**Response to Defense Nuclear Facilities Safety Board (DNFSB) Comments
in DNFSB Letter dated November 4, 2002**

The following information identifies each of the DNFSB comments or issues and provides a U.S. Department of Energy (DOE) response, identifies actions taken to date, and actions that are currently planned to support construction activities.

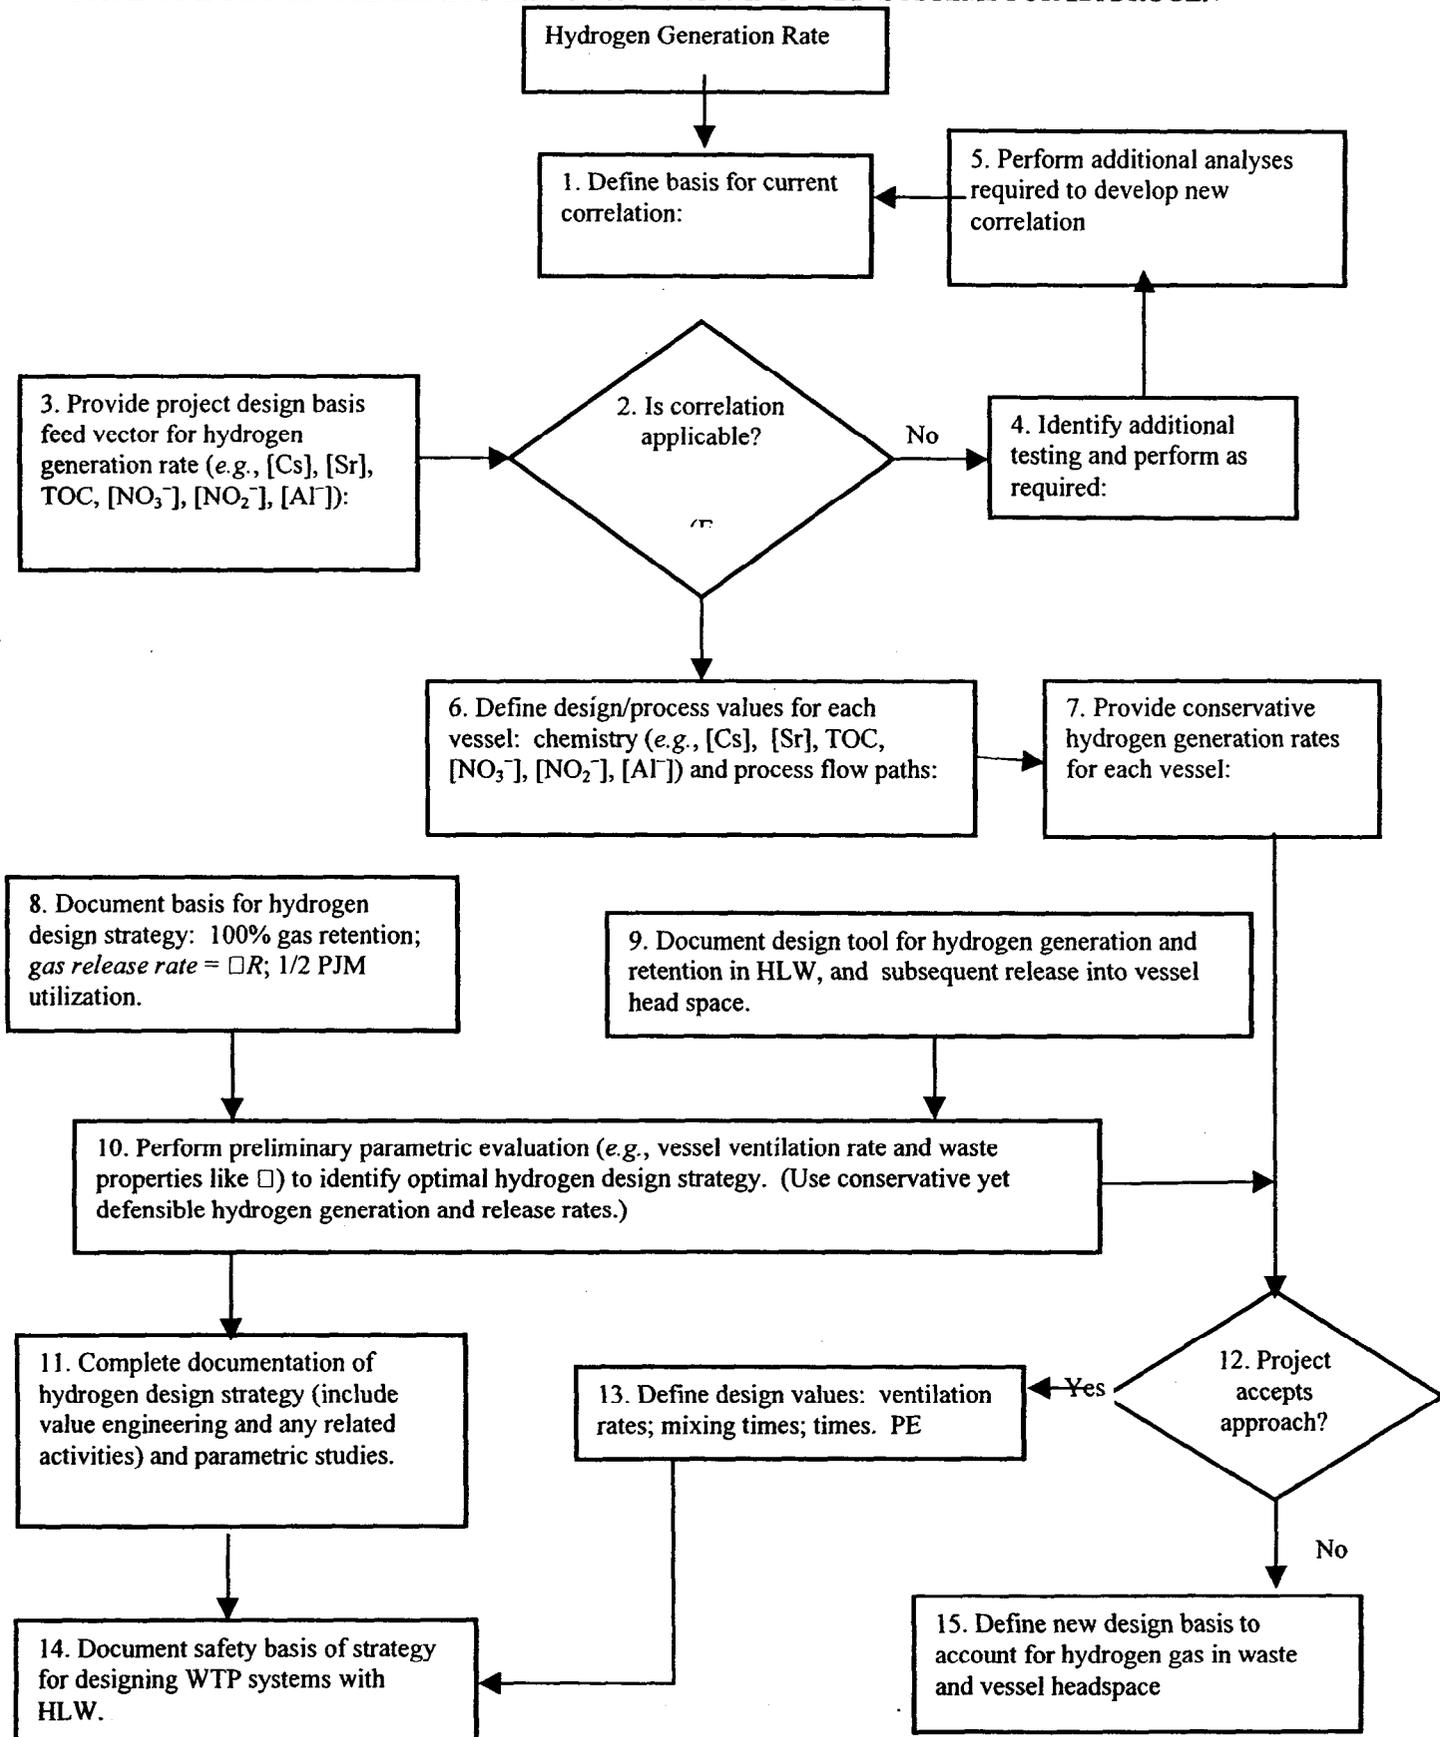
In at least one instance, the model underpredicted by approximately 25 percent the hydrogen generation within Tank AW-101 compared to that tank's measured generation rates. This discrepancy is significant as Tank AW-101 will provide feed during the initial WTP operating period (Phase 1). Moreover, this discrepancy demonstrates that the current model may not yield conservative or bounding hydrogen generation rates. A proper understanding of the driving mechanisms behind hydrogen generation and the sensitivity of various inputs is required, rather than an increase in the conservative estimates for some individual inputs. Additionally, as the PVP system is currently in design and nearing procurement, a sufficiently conservative predictive model for hydrogen generation rates needs to be developed in a timely manner.

BNI has chosen to model hydrogen generation rates using a model developed for the tank farms. This model was developed in the early 1990s to better understand flammable gas generation in Tank SY-101. This approach may not produce sufficiently conservative generation rate values since it does not address other important variables involved in hydrogen generation. In at least one instance, the model underpredicted by approximately 25 percent the hydrogen generation within Tank AW-101 compared to that tank's measured generation rates.

DOE agrees that using the 1997 hydrogen model developed for the tank farms and conservative input values to model hydrogen generation rates may not produce sufficiently conservative generation rate values.

In light of the issues raised by the DNFSB staff regarding the shortcomings of the correlation, (i.e., under prediction and no consideration of alpha), an effort was undertaken to demonstrate that by using conservative input parameters, including the effect of alpha emitters, a bounding defensible hydrogen generation rate could be developed. The plan to remove uncertainty in the understanding of hydrogen generation is shown graphically in the following Figure.

BNI has completed the activities identified in boxes 1 through 7 of the Figure, and concluded the correlation identified in RPT-W375-SA00002 is not a conservative methodology for predicting hydrogen generation rates (See 24590-WTP-RPT-RT-02-006, *Predicting Hydrogen Generation Rates in Radioactive Waste Materials* for further discussion) (referred to as the R&T report). Using conservative input values for envelopes A and B the Topical Report correlation under predicted hydrogen generation in Tank AW-101; however, for envelope C, the correlation over predicted hydrogen generation in Tank AW-101.
